Product Change Notification

Issue Date: November 5, 2015

Product Name: NOVA-PV-D5251	Status: Running change								
Reason for Change Scalar IC NT68667UFG already have been EOL, and IEI has run out of the stocks of NT68667UFG.									
Description of Change 1. Change Scalar IC from Novatek NT68667UFG to Novatek NT68660BUFG									
Affected Model

NOVA-PV-D5252/D4252/N4552-R10

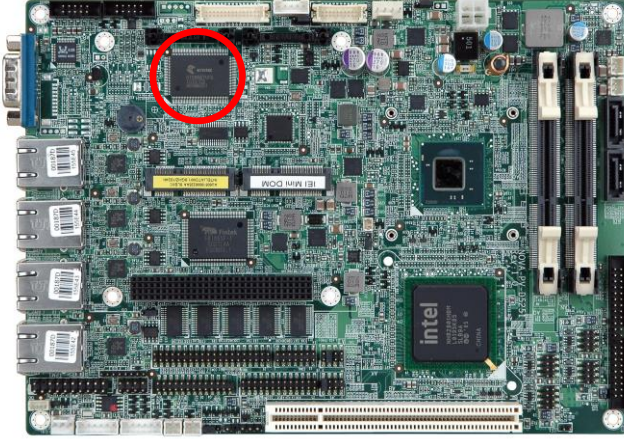
Original Scalar IC: Novatek NT68667UFG

Change Scalar IC to Novatek NT68660BUFG
Add Heatsink for Scalar IC
